# Value Engineering Study

**Kentucky  
Transportation Cabinet**

**I-65 & KY 222 Interchange**

**Hardin County**

Alternative No.: IO-12

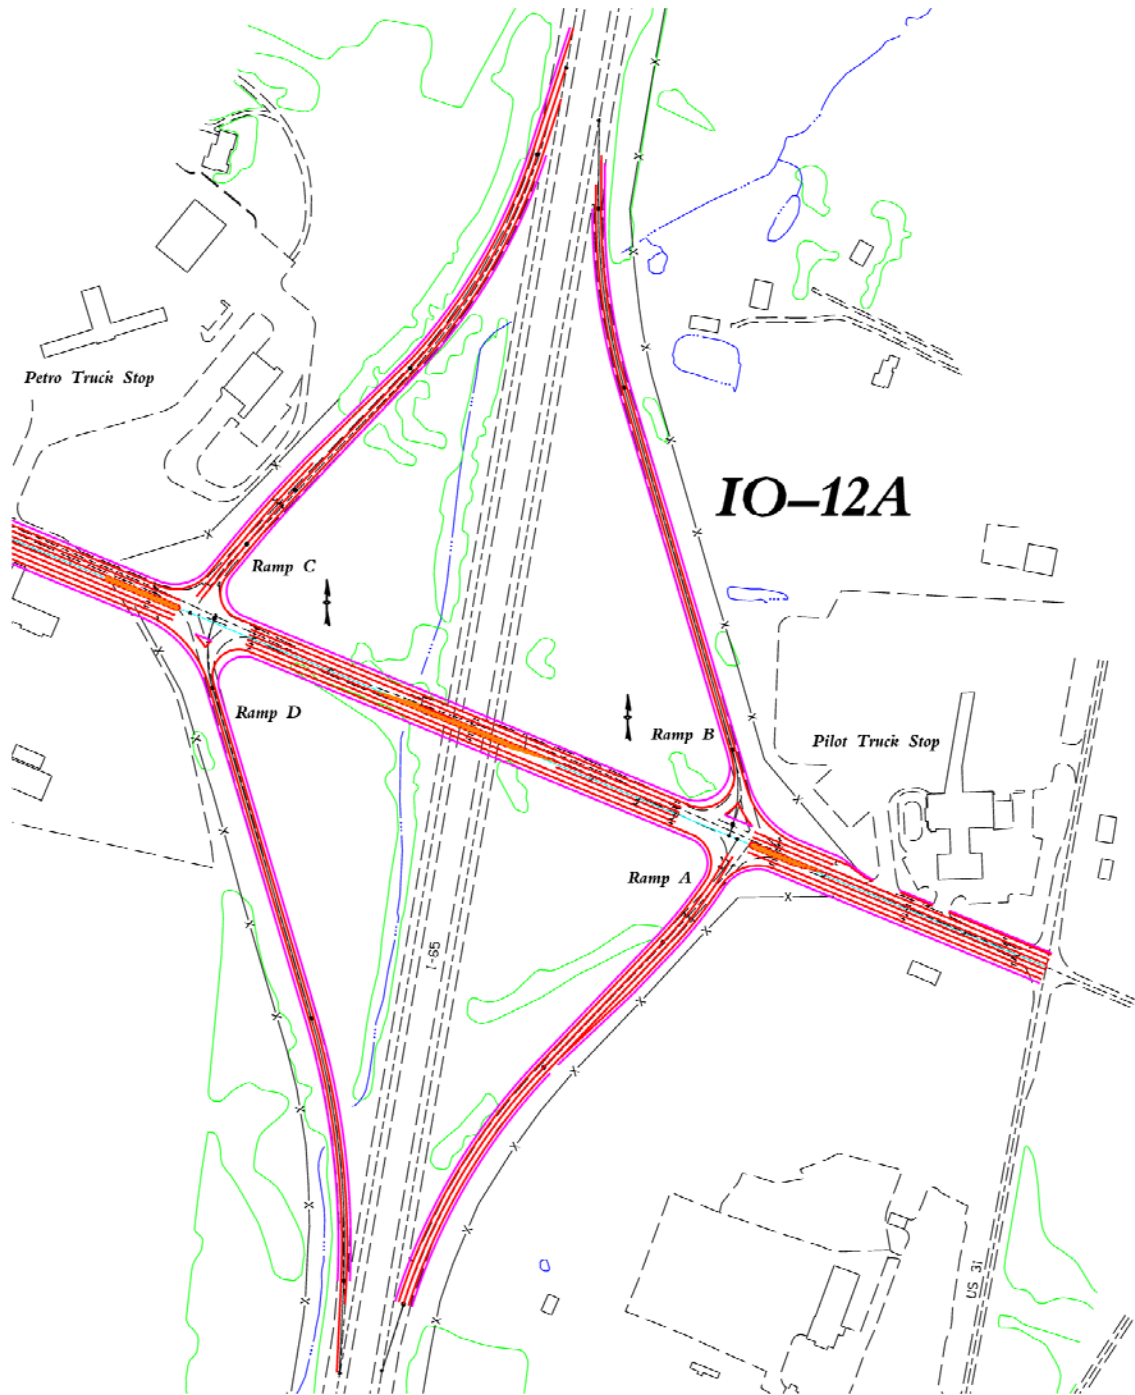
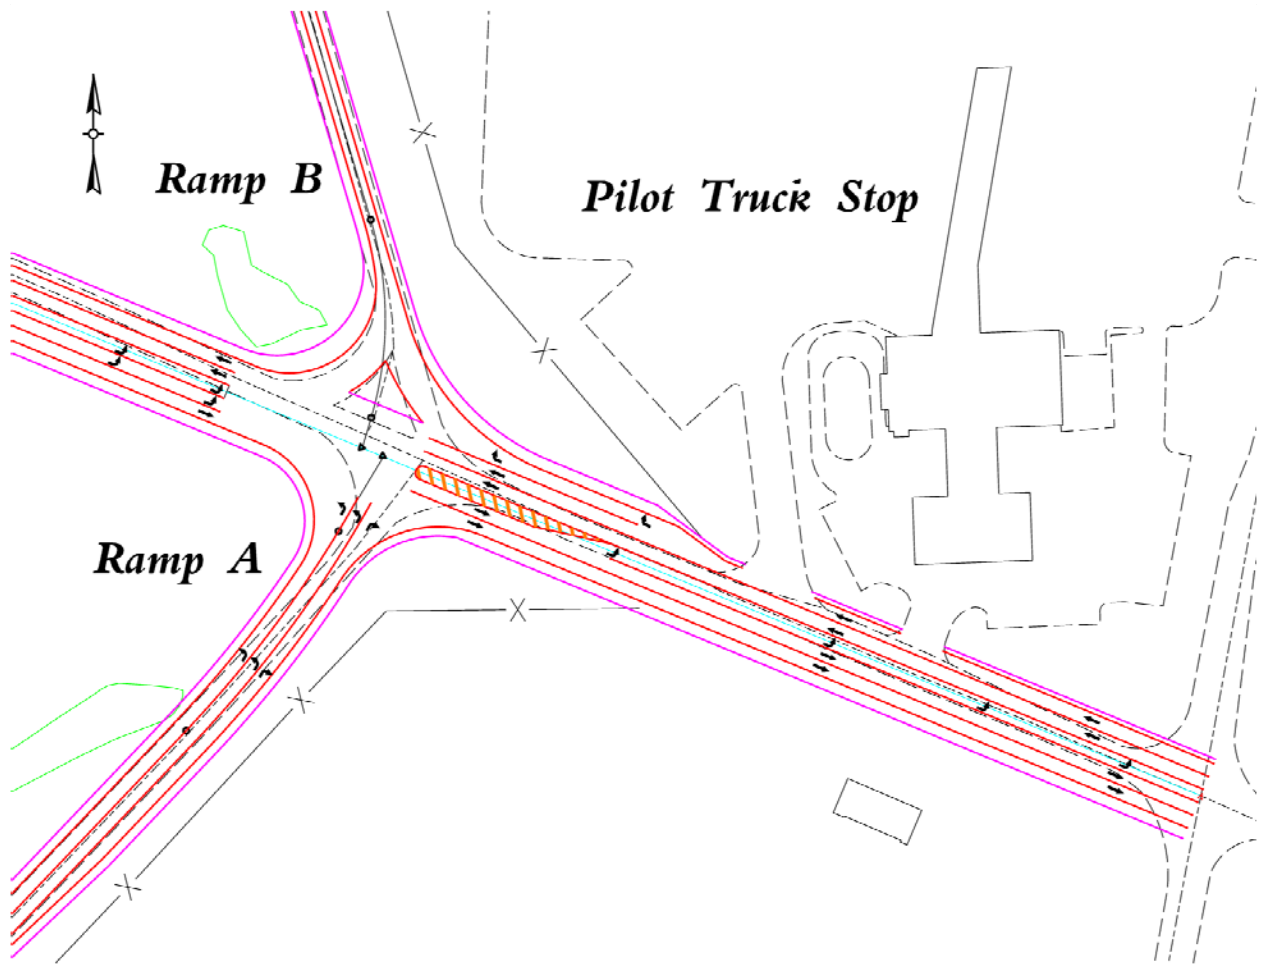
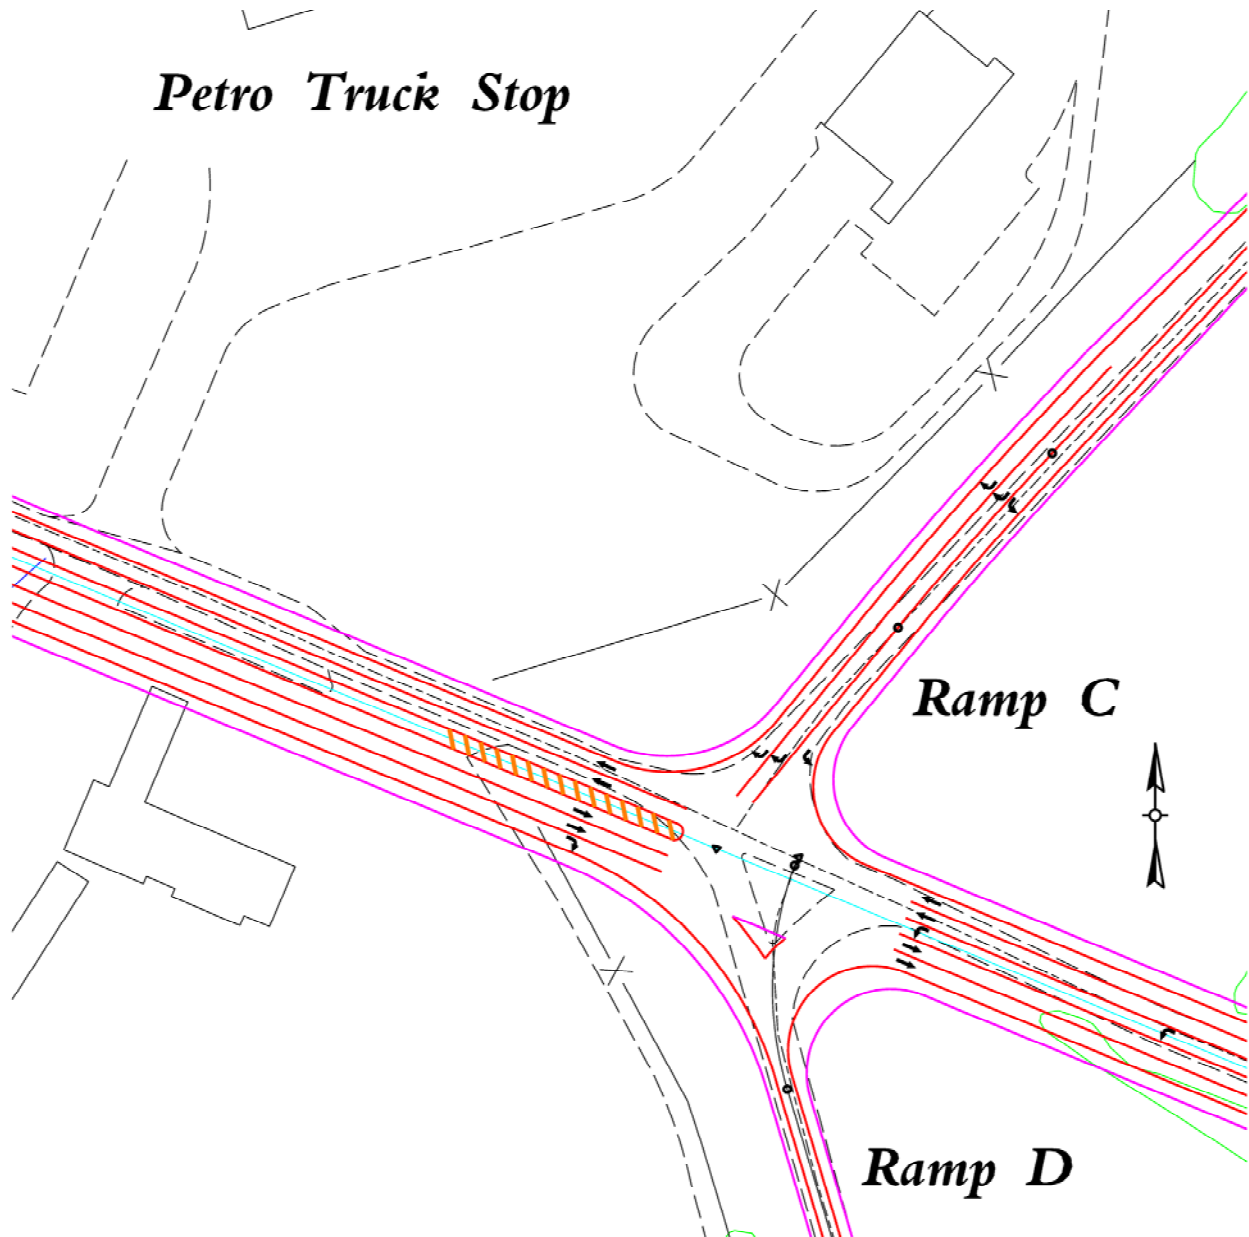
Alternate	R/W	U	C	Total
SPUI	\$3,600,000	\$850,000	\$27,750,000	\$32,200,000
IO-12A	\$900,000	\$650,000	\$20,500,000	22,050,000
IO-12B	\$900,000	\$650,000	\$21,900,000	\$23,450,000

Alternative No.: IO-15

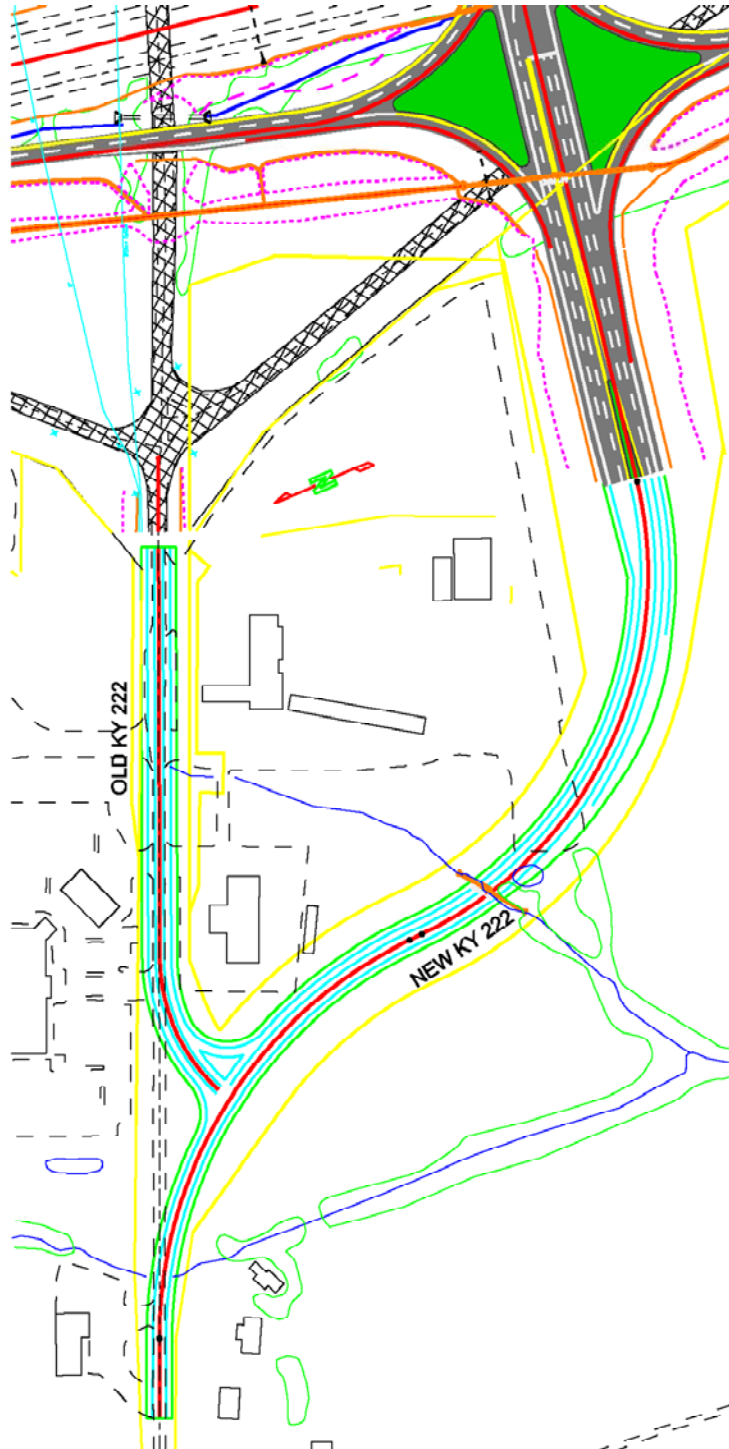
The alternative concept would not impact the farm pond thus eliminating the corresponding wetland impacts expected in the original concept.

This alternative eliminates the west roundabout shown in the Preferred Alternative.

Alternative No.: IO-31

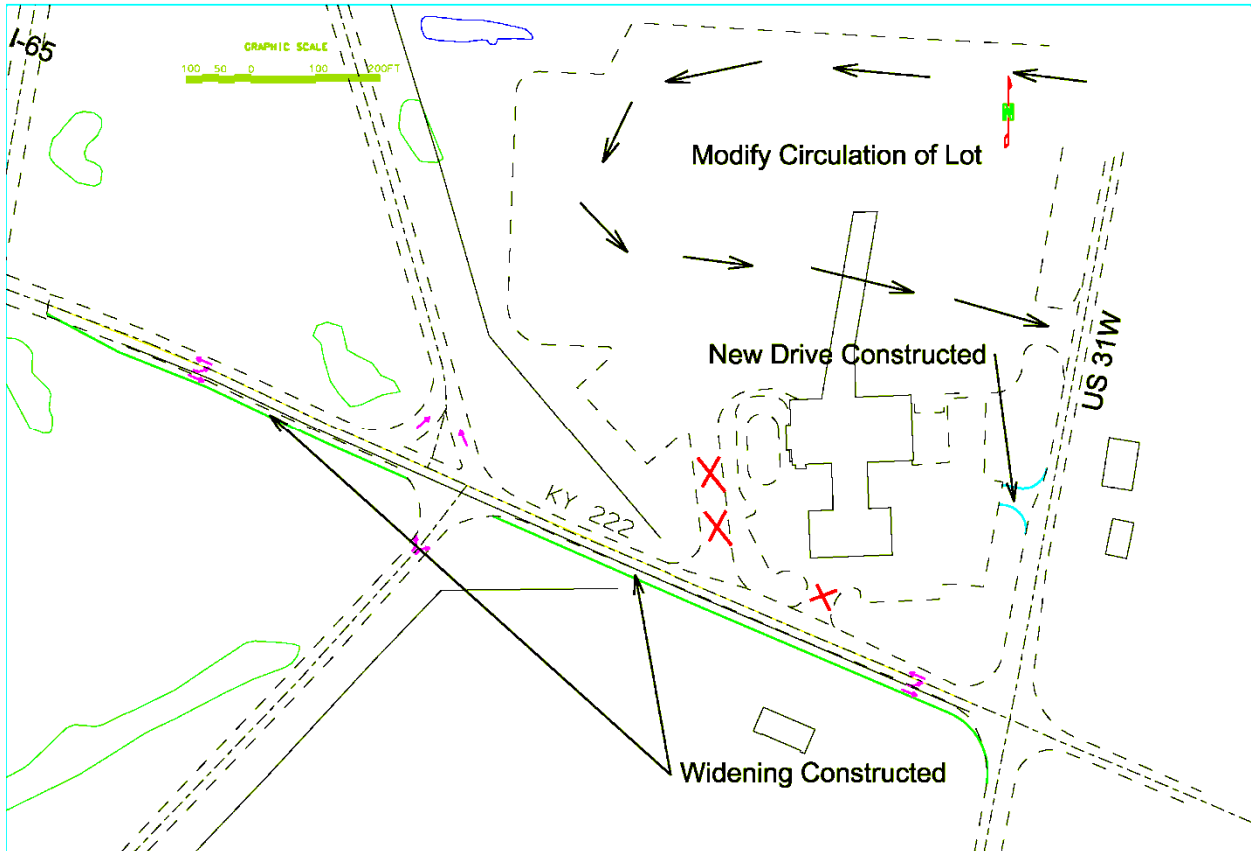
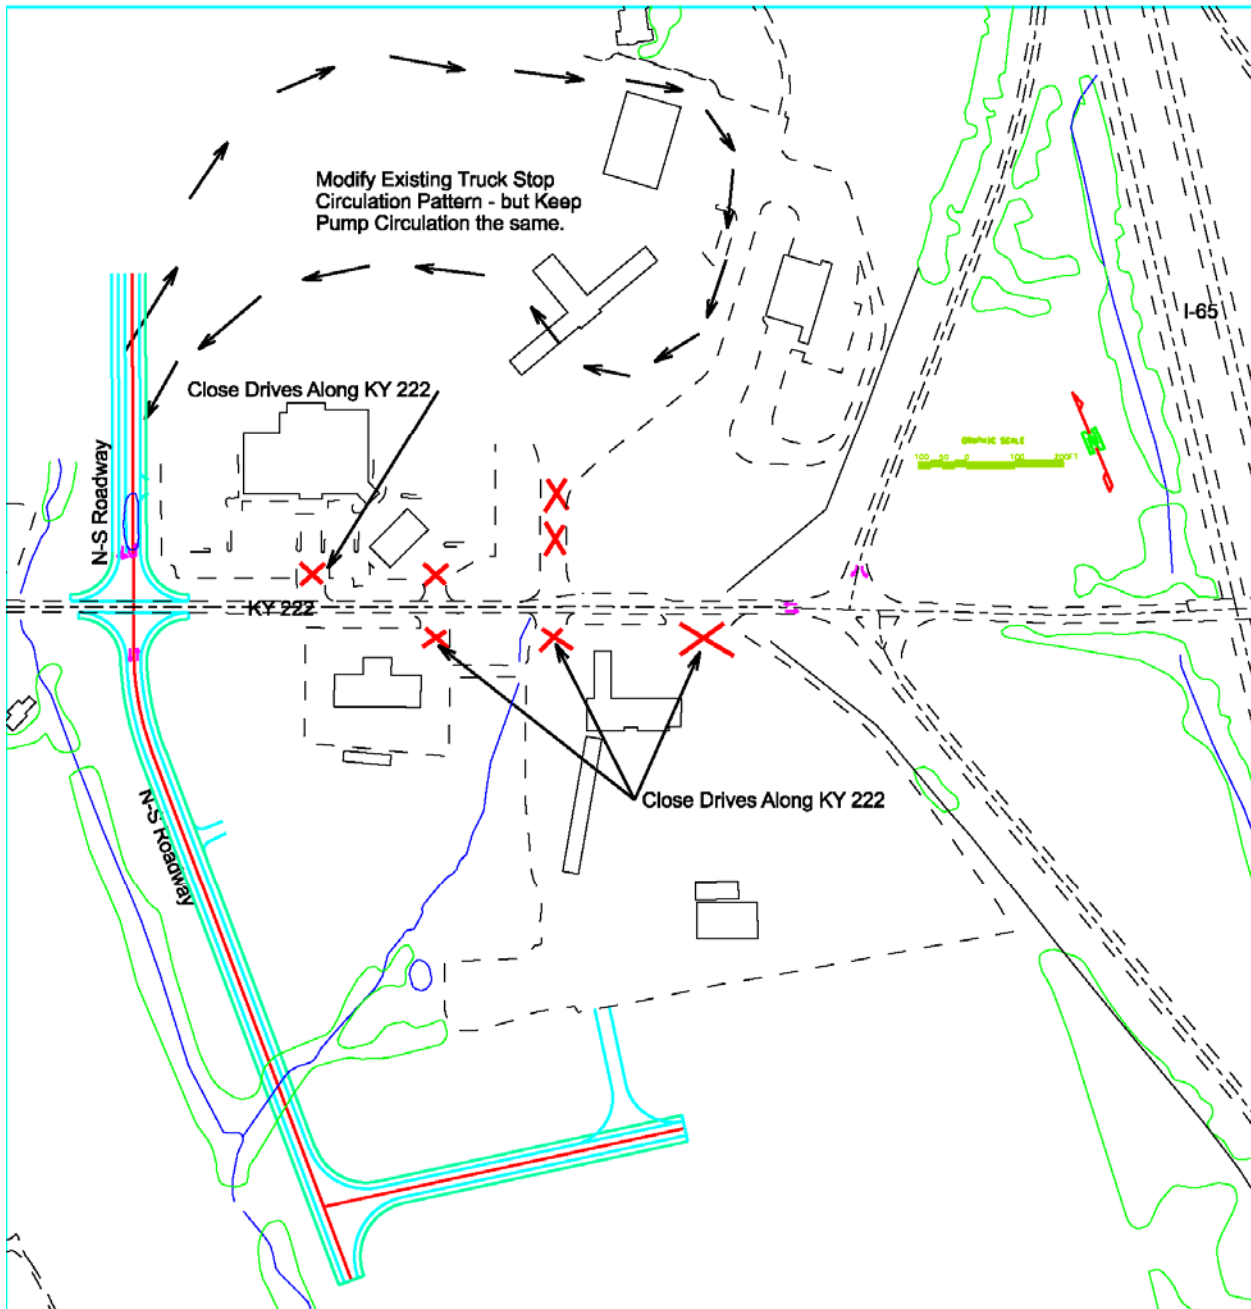
A new intersection would be created just west of the Petro truck stop. A new North-South (NS) roadway would be constructed with a roundabout or signalized intersection. The driveways for the Petro (both truck and car entrances) as well as the driveways to Glendale Economy Inn and Country Style Plaza would be relocated to this new NS roadway. The new NS roadway could provide access to the potential future industrial development site. The existing commercial driveways along KY 222 would be closed to provide approximately 1,200 feet between the ramp intersection and the NS roadway.

The Petro parking lot would likely need to be re-striped to change the circulation of trucks traveling to the gas pumps.

A signal would be added to the existing intersection of KY 222 and US 31W.

Construction sequencing of this concept would require partial width construction of most features of this project. The bridge, ramps, KY 222, and US 31W would need to be constructed half at a time to maintain traffic.

Traffic operations in the design year 2030, assuming the development site is not operating, the ramp intersections will operate at a LOS A/B with no more than 20 seconds of delay.

Alternative No.: IO-39

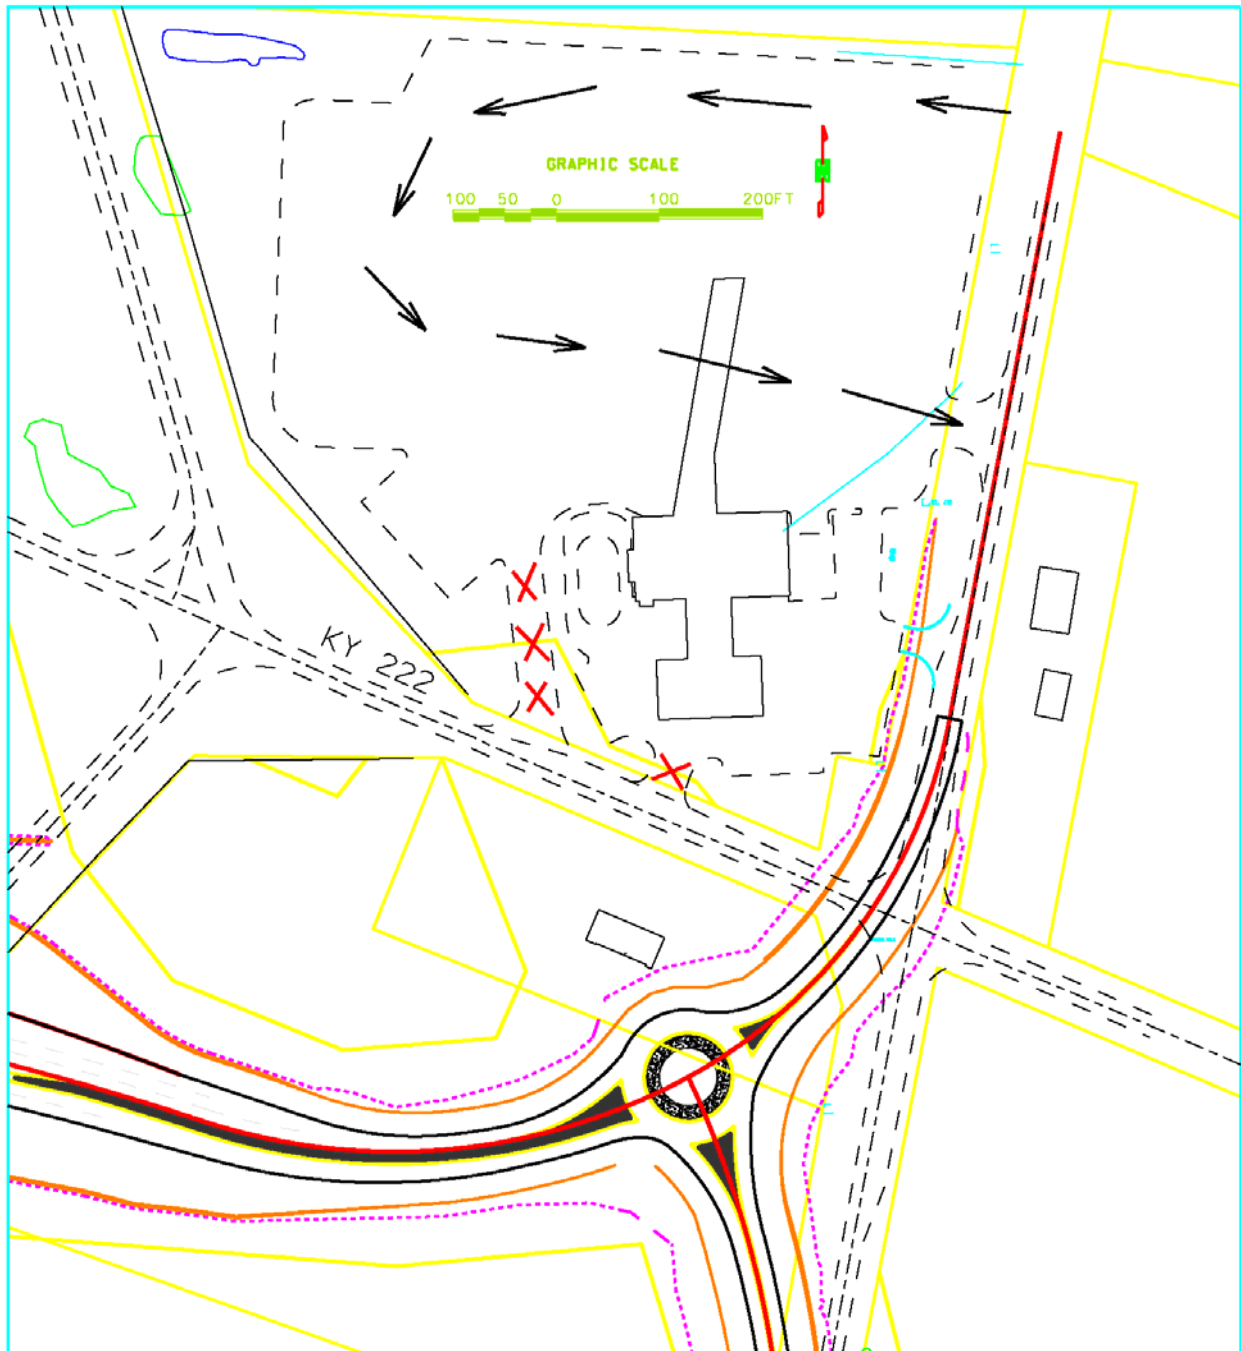
This alternative would eliminate the northwest leg of the roundabout serving the Pilot Travel Center; redirecting truck traffic onto US 31W. Internal circulation patterns at the Pilot Travel Center would be revised in order to allow entry at the northern Pilot Travel Center access on US 31W; egress operations would remain at the southern access point. Passenger car traffic would be served by a new access point north of the proposed roundabout. US 31W would be widened to serve northbound left turning into the truck stop.

The alternative concept eliminates this circulation conflict by reversing the direction of flow at the northern parking area of the Pilot Travel Center. Ingress traffic on US 31W would be served through the construction of a left turn lane on US 31W by widening to the west of US 31W across the Pilot Travel Center and Calvary Mission Church property.

This minor change in design would improve the level of service of the KY 222 & US 31W intersection.
